Burrendong Wind Farm

Amendment Report

Ark Energy

Figure 3-2: Amended Project Layout

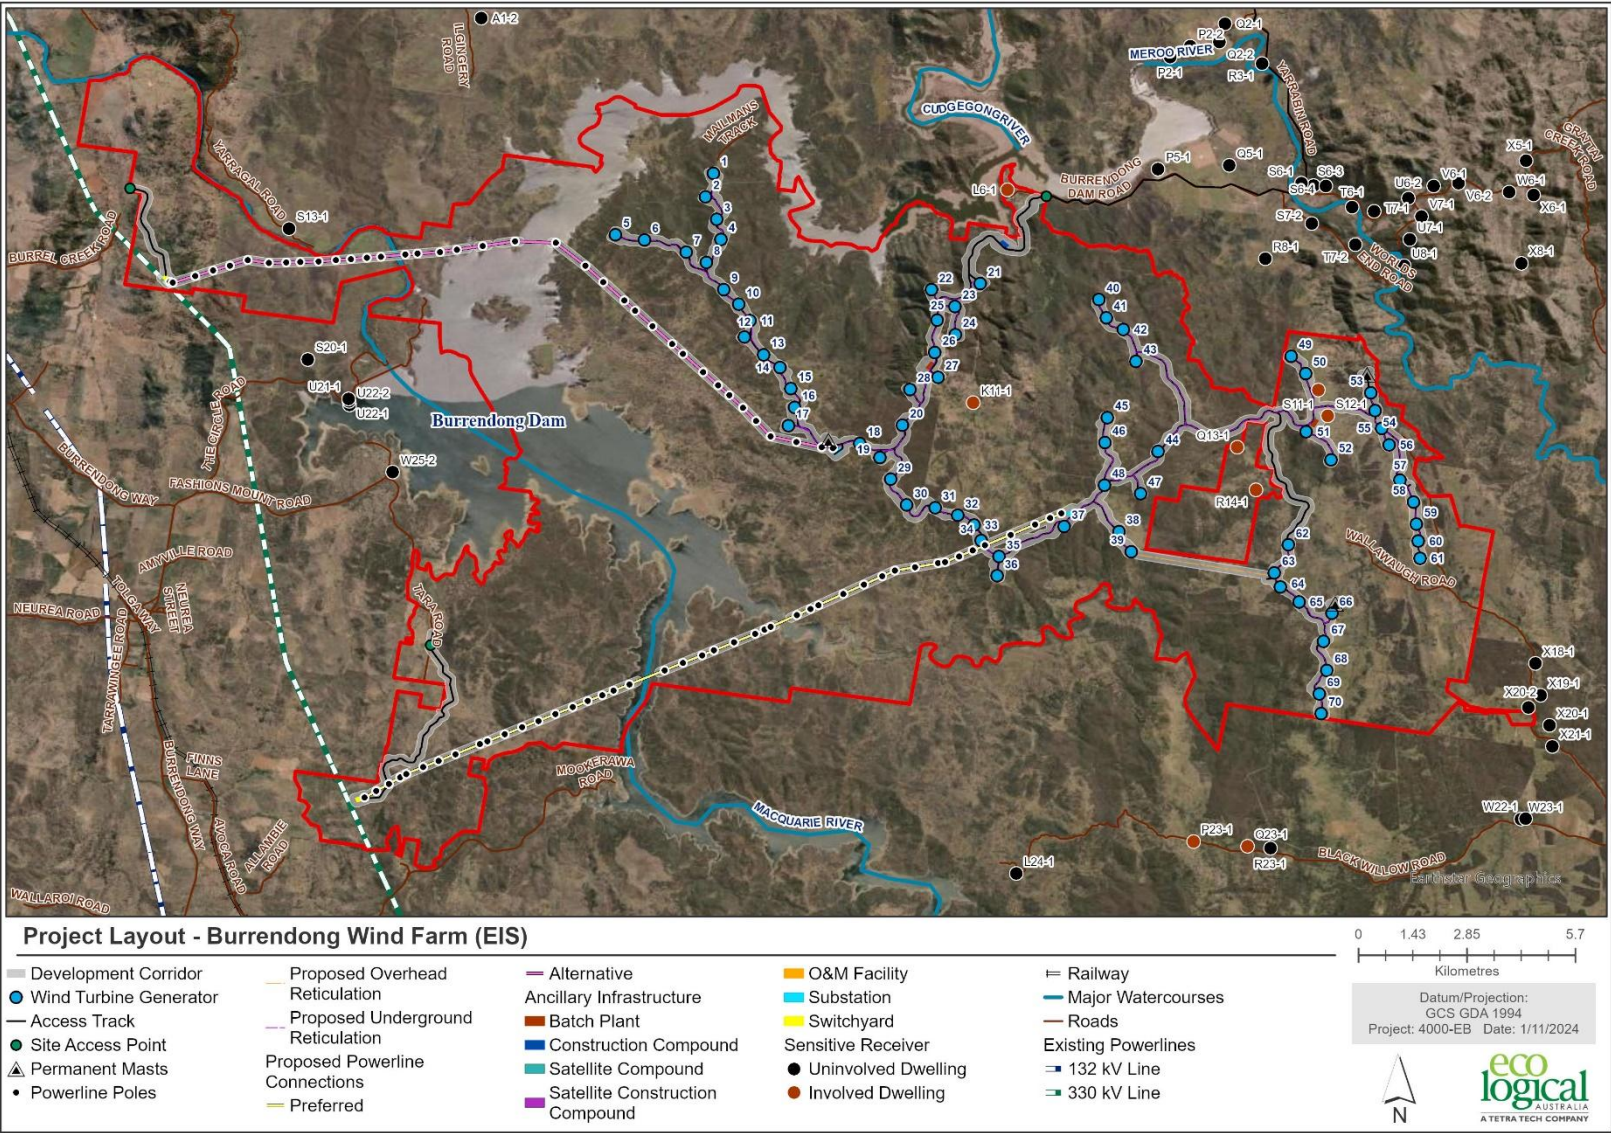
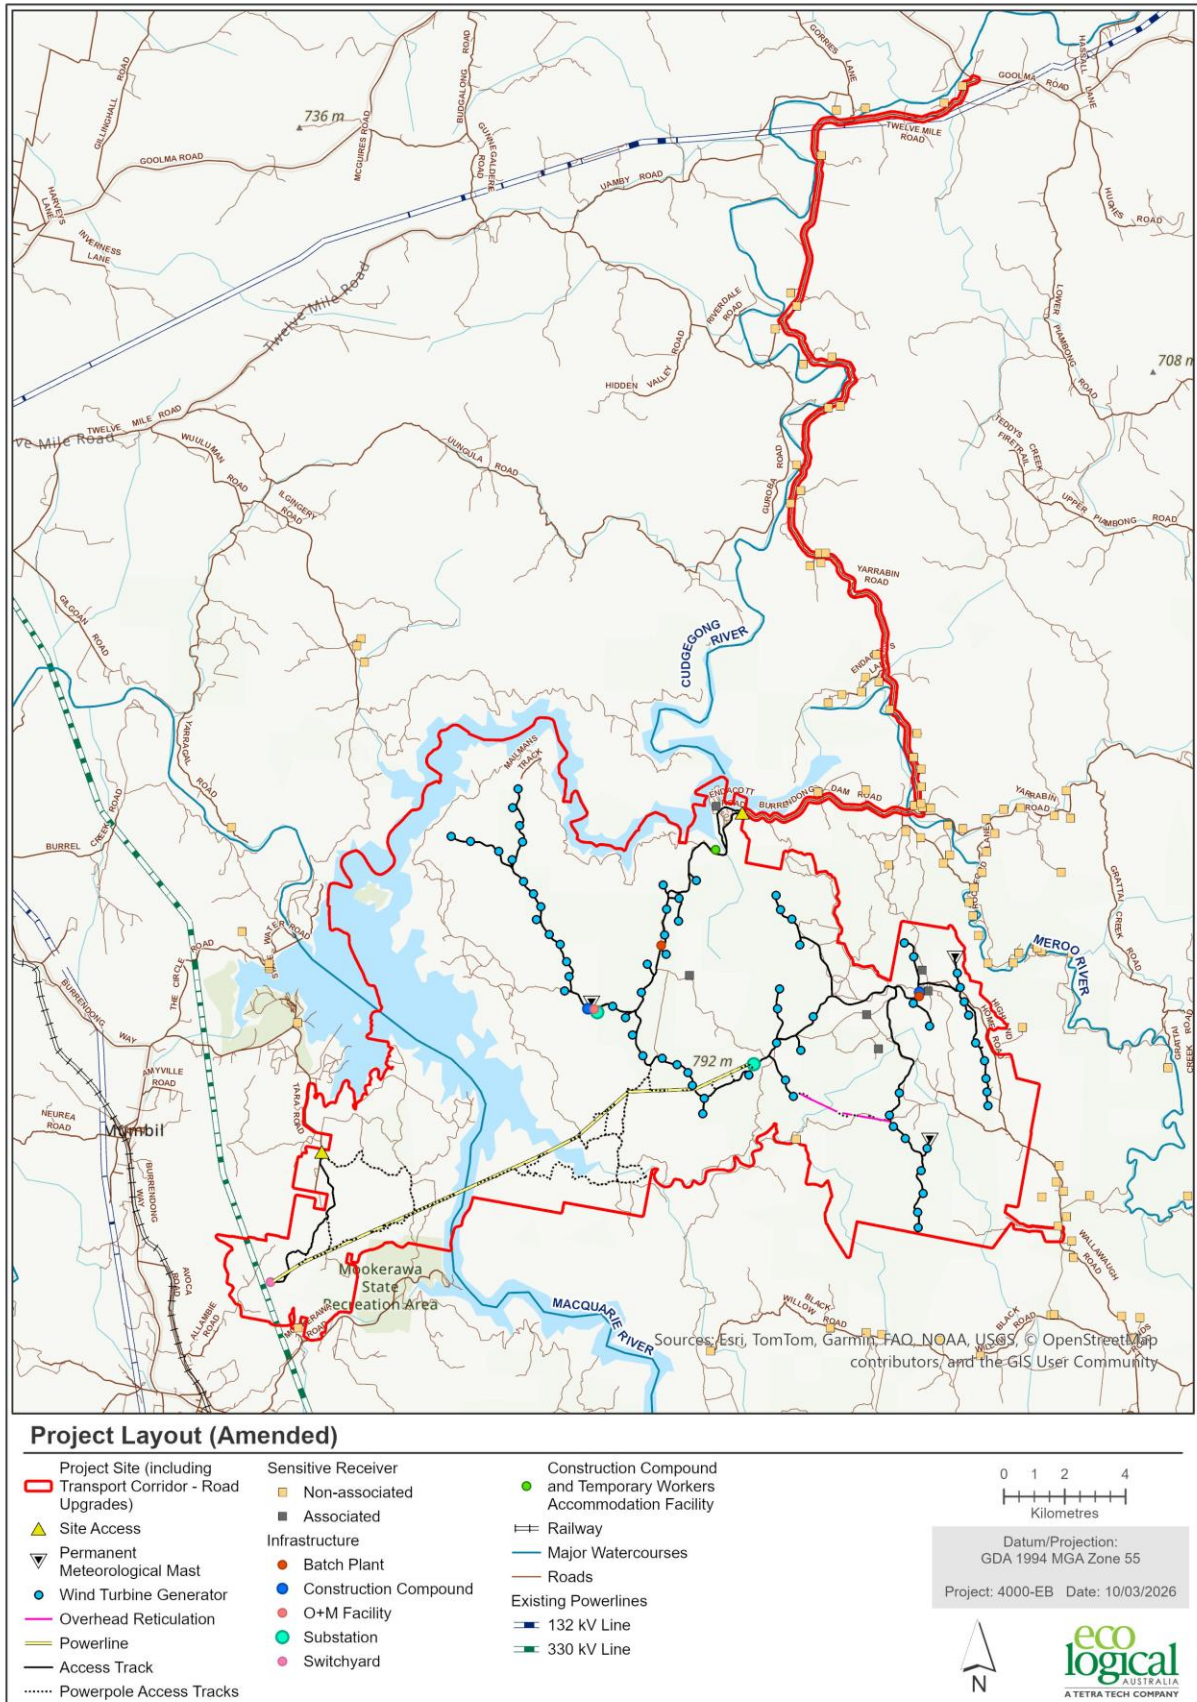
An overview of the Project amendments compared to the project included in the original development application is provided in Table 3-2 and Figure 3-1 shows the EIS Project while Figure 3-3 shows the amended Project. Further details of the amendments are described and depicted in more detail throughout this section.

Figure 3-3: Amended Project Site – Site Access upgrades (Public road and intersection)

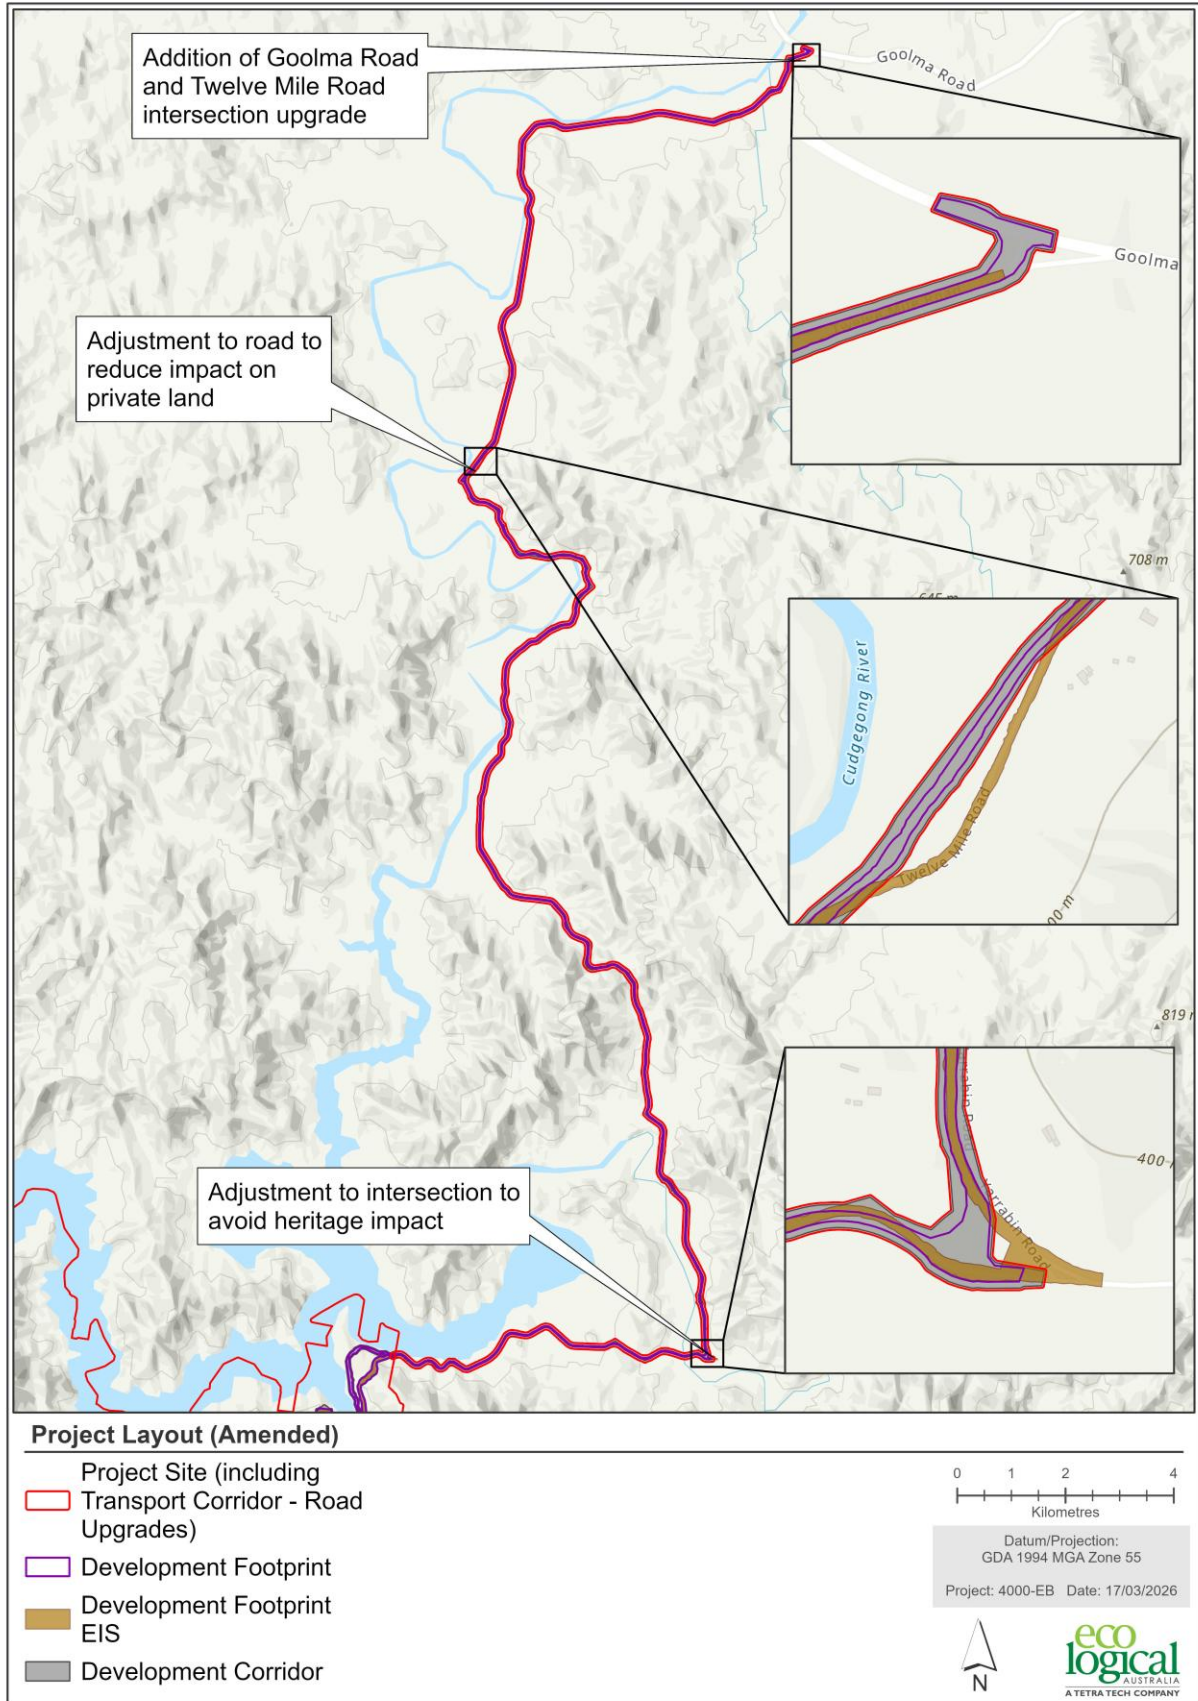
The Project Site (boundary) has been expanded to include the road upgrade corridor which encapsulates the proposed upgrades works on the local public roads (Figure 3-2 and Figure 3-3). The impacts of the road upgrades have been assessed as part of the overall impact of the Project.

Figure 3-3 illustrates the expansion of the project footprint corridor to account for the intersection upgrade impacts.

Figure 3-5: Amended Project Layout

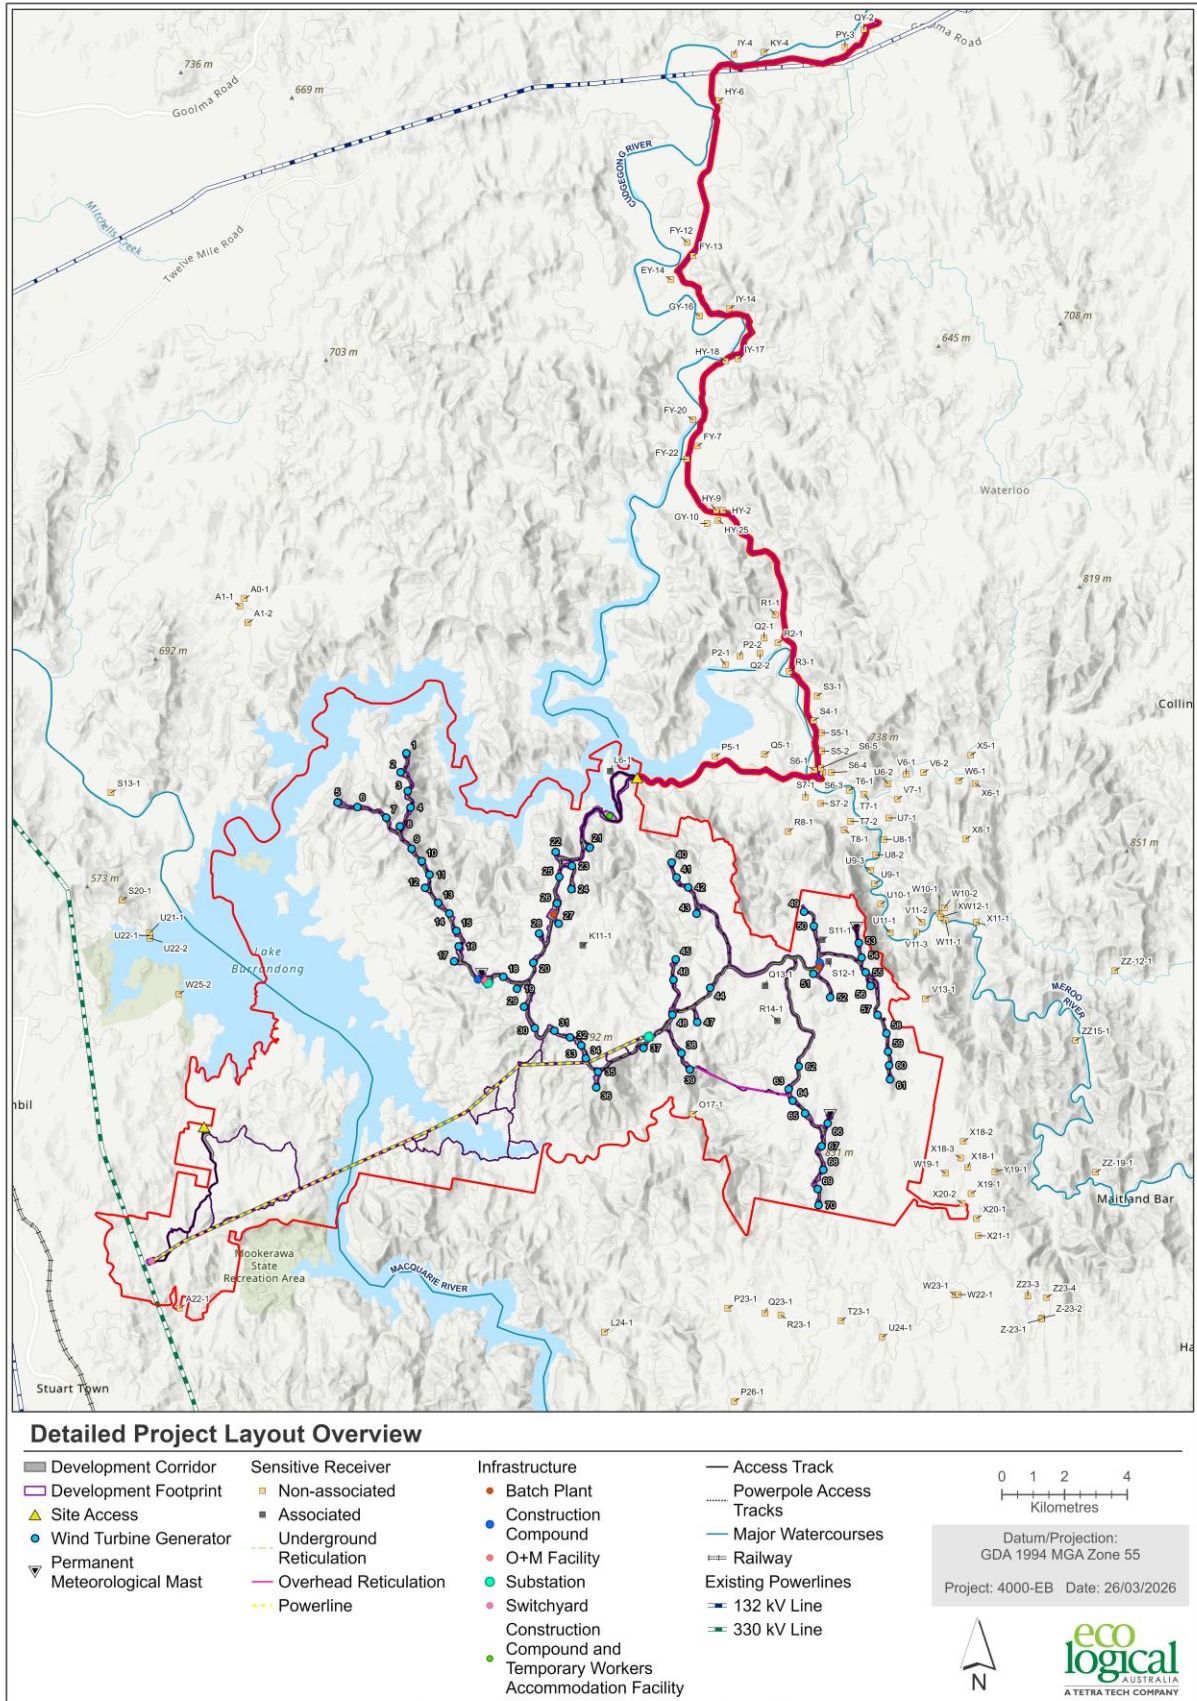
Land has been removed in the northwest area of the Project Site due to the removal of the northern transmission line option (see Figure 3-5) for the amended Project Site (in red) and the (old) EIS Development Footprint (in gold)).

Figure 3-7: Amended Project Layout – Access Options

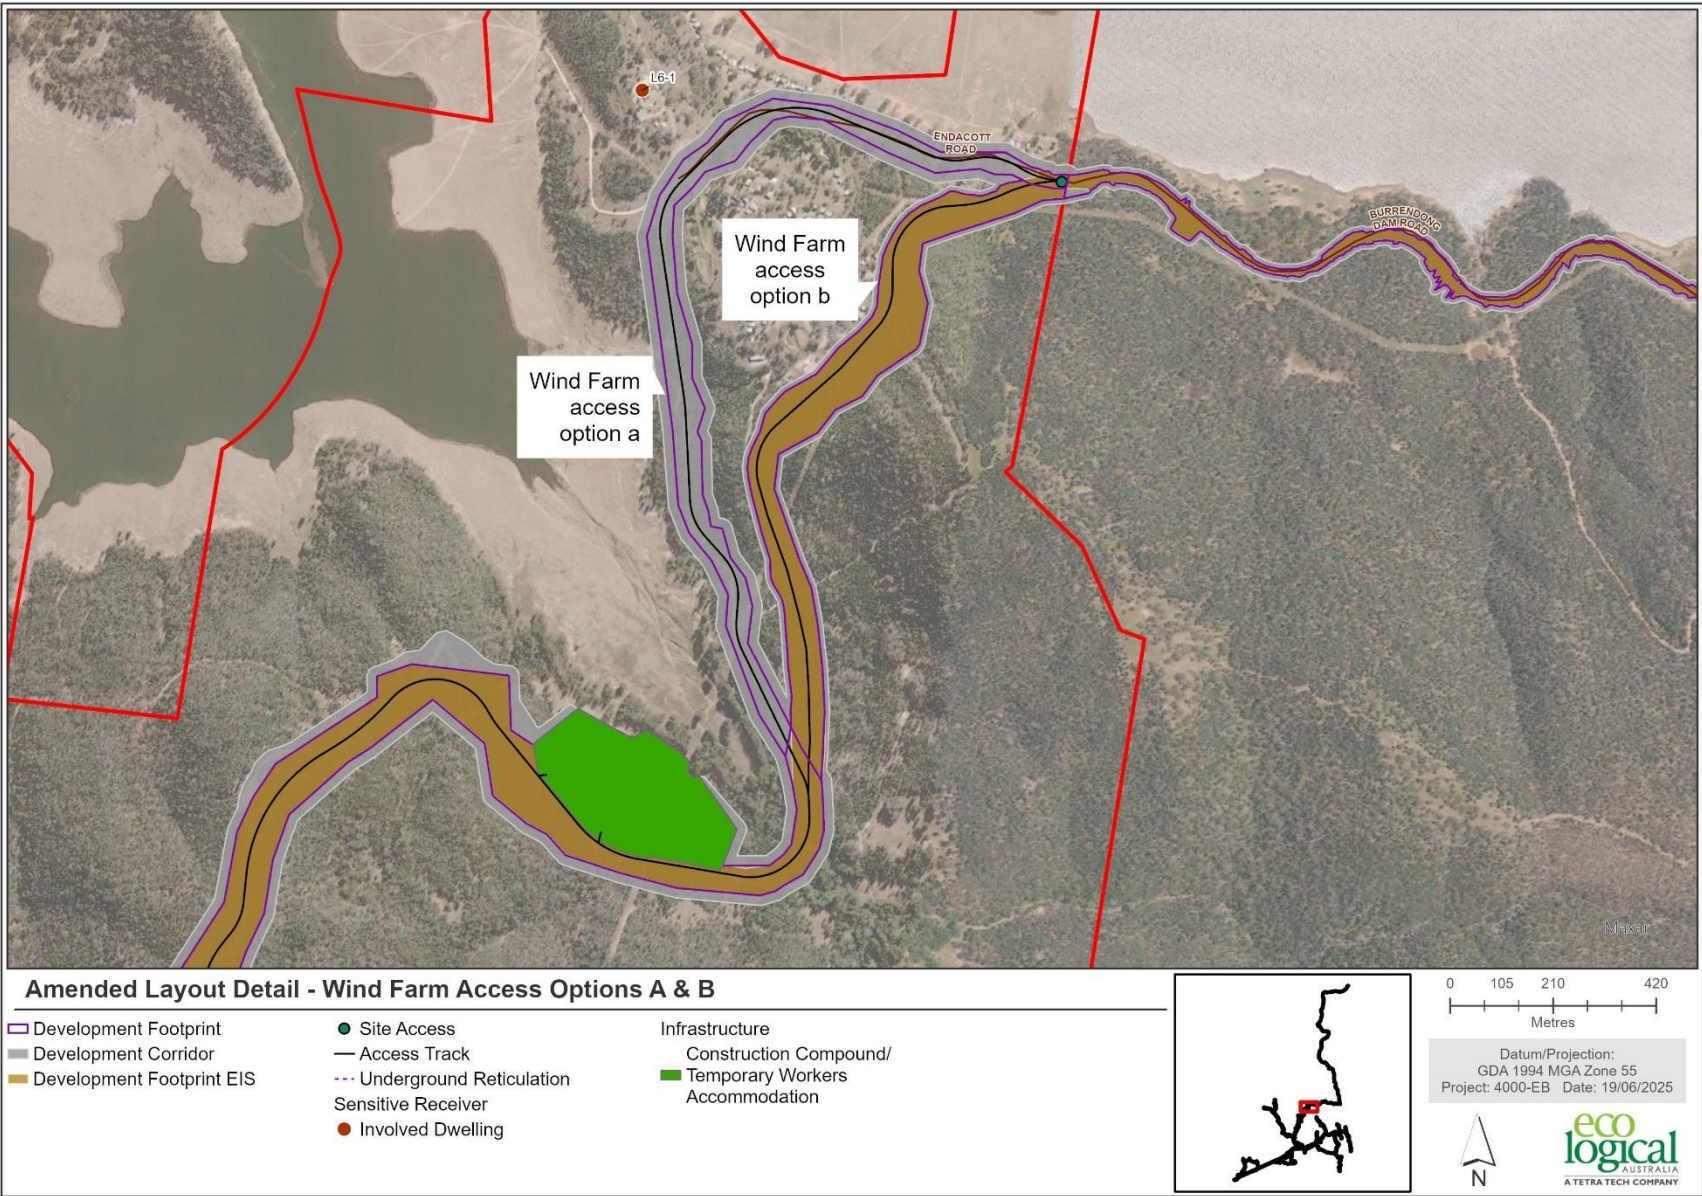
- An existing track near the Project Site access that passes through the Reflections Cudgegong River holiday park has been incorporated as part of the proposed wind farm access track. This amendment provides flexibility during detailed design. While both options have been included and assessed as part of the amended project, only one option will be selected during detailed design. The route options can be seen in Figure 3-7:
